Re: Former Chevron Service Station 209339
5940 College Avenue
Oakland, California
ACEH Case RO0000466

Re: Response to Technical Comments and
Work Plan Addendum
Former Chevron Service Station 209339
5940 College Avenue
Oakland, California
ACEH Case RO0000466

Subject: Conditional Work Plan Approval; Fuel Leak Case No. RO0000466 and Geotracker Global ID T06019752694, Chevron #20-9339, 5940 College Avenue, Oakland, CA 94618

Figure 1 Vicinity Map
Figure 2 Site Plan

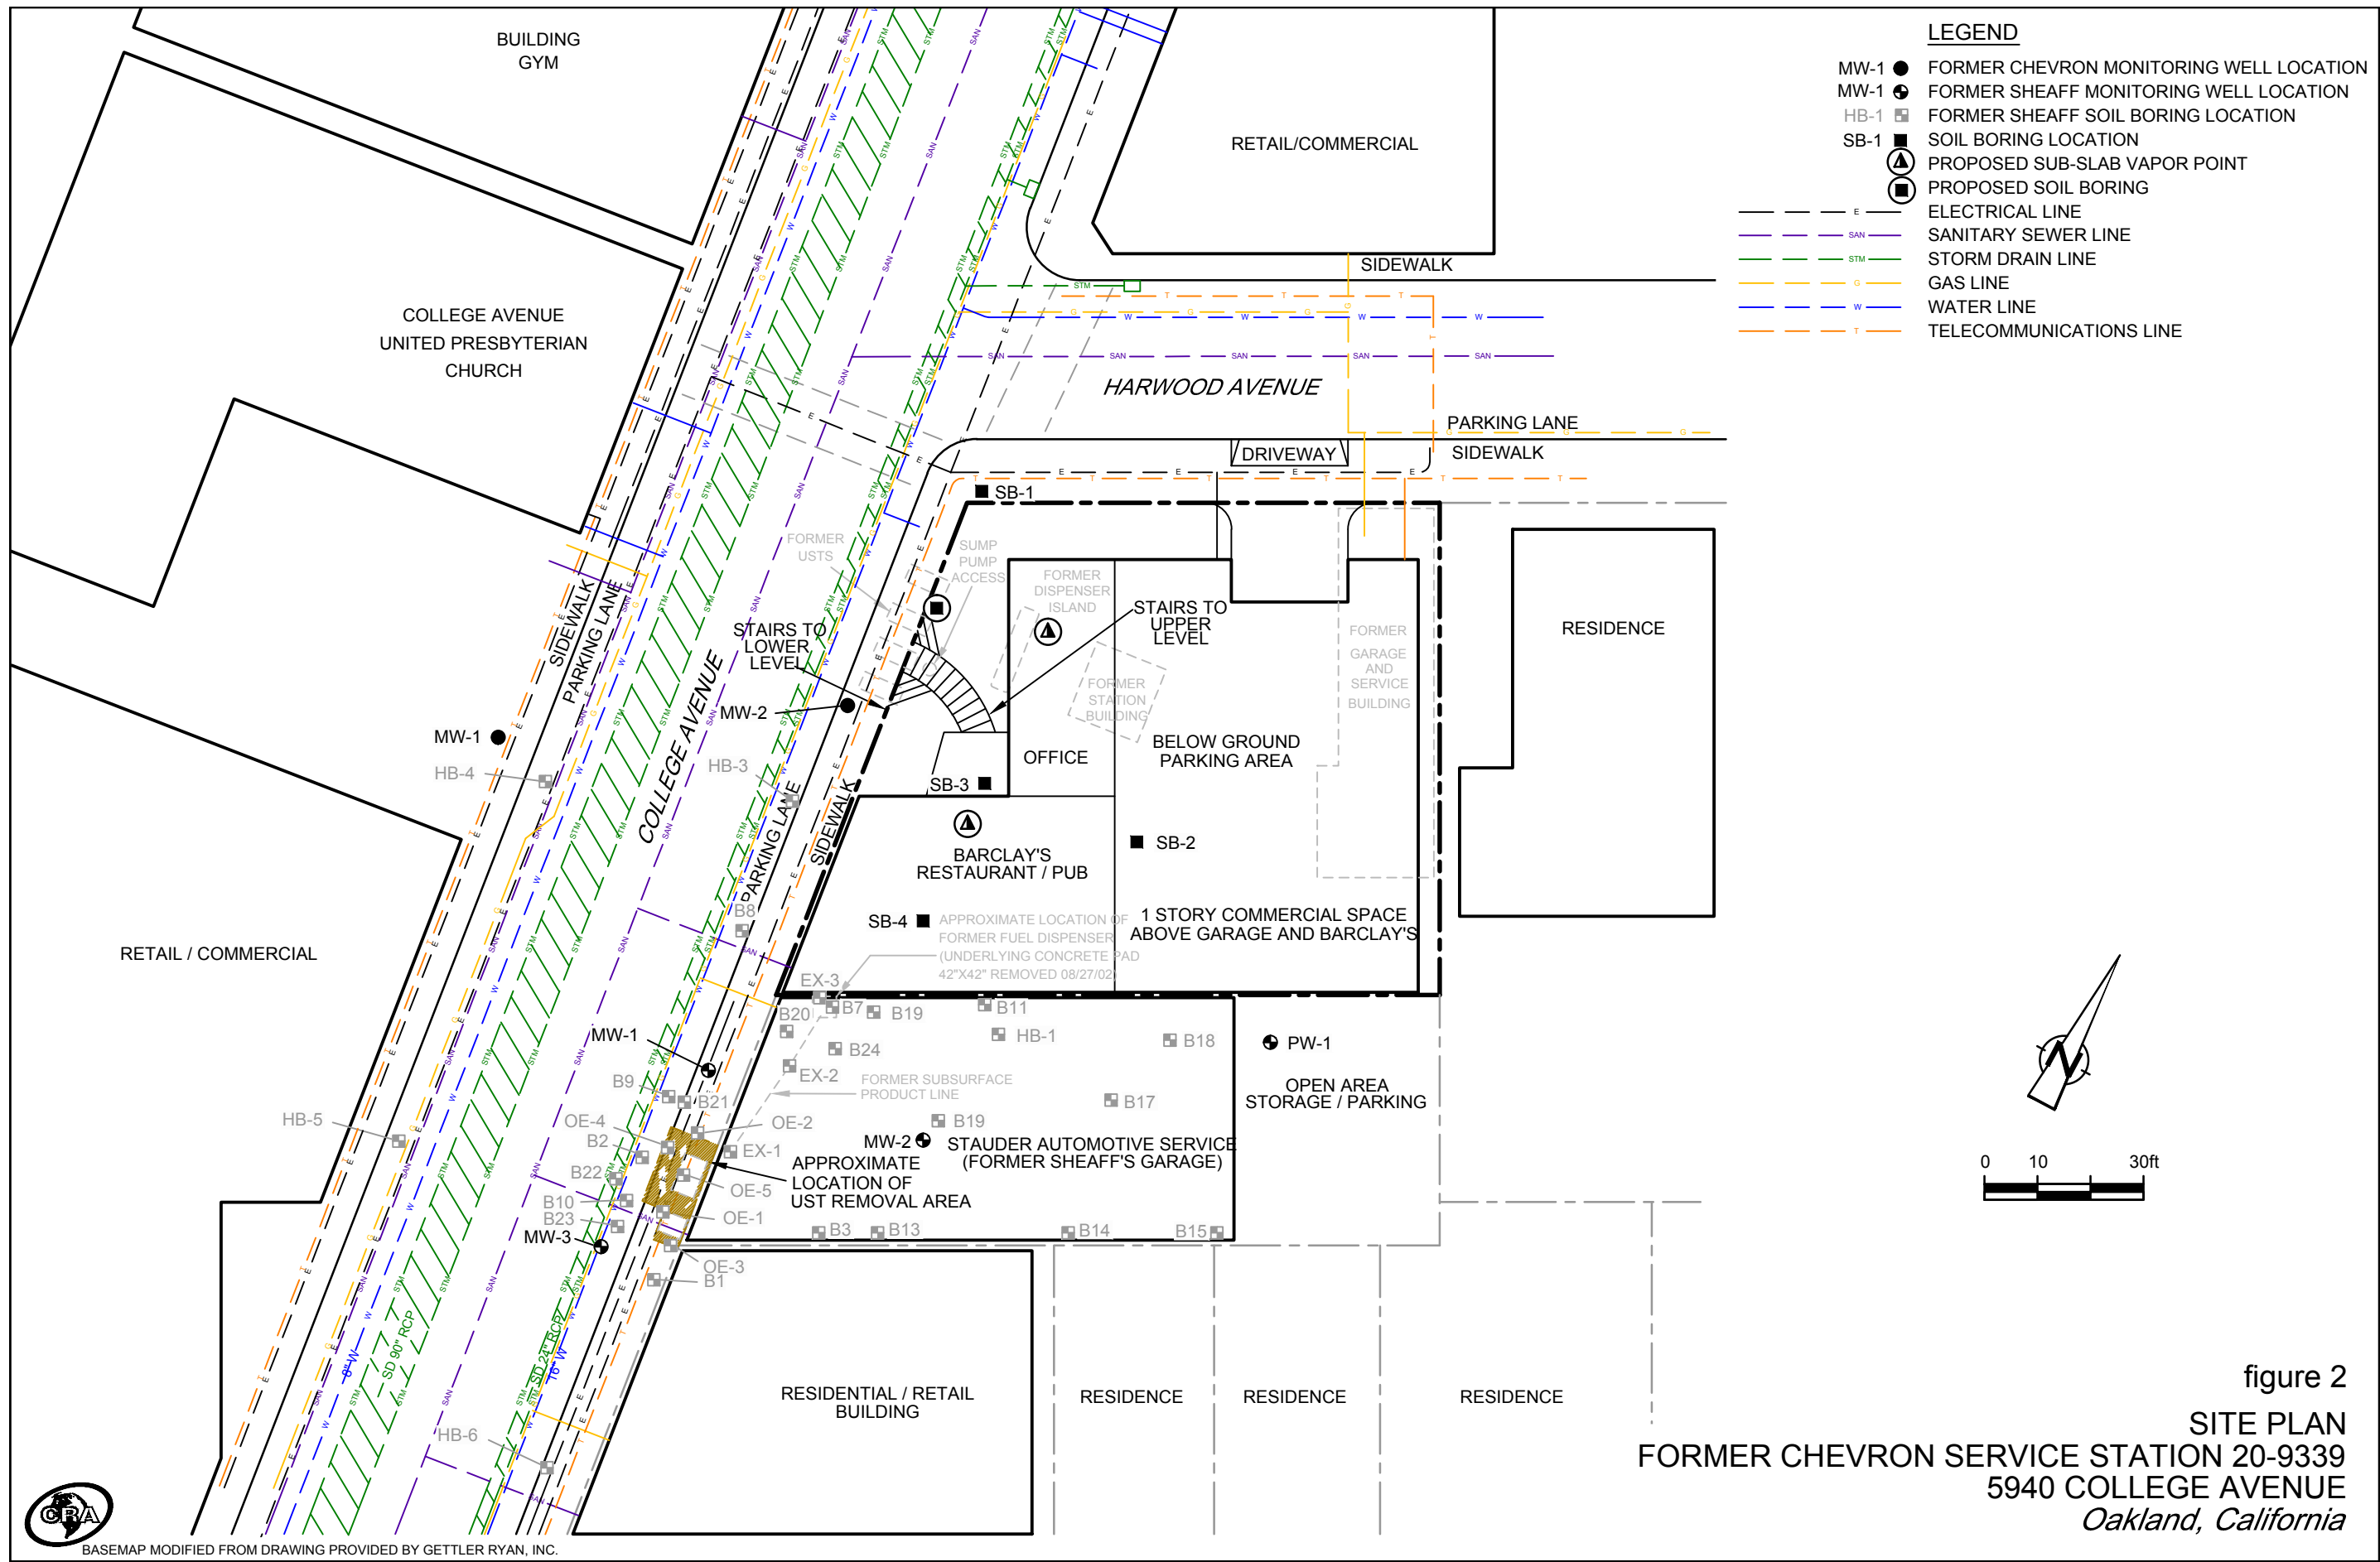
Technical Comment 1a: Proposed Soil Boring Location

"...requests the bore be located immediately adjacent to the presumed former underground storage tank (UST) locations rather than as depicted between the USTs and dispenser."

- a. **Proposed Soil Bore Location** - The work plan proposes to install one 5-foot soil bore between the presumed former locations of a number of underground storage tanks (USTs) and the former fuel dispenser. ACEH is in agreement that collection of the data is appropriate; however, requests the bore be located immediately adjacent to the presumed former underground storage tank (UST) locations rather than as depicted between the USTs and the dispenser. This is an effort to determine residual source area contamination in proximity to multiple former USTs. It is presumed that the vapor sample can provide data on the fuel dispenser area.

As shown on the revised Figure 2, the location of the proposed soil boring will be moved west so that it is adjacent to the former USTs. The final location will be determined in the field after a subsurface utility locate has been performed to ensure the boring location is a minimum of 5 feet from any subsurface utilities.
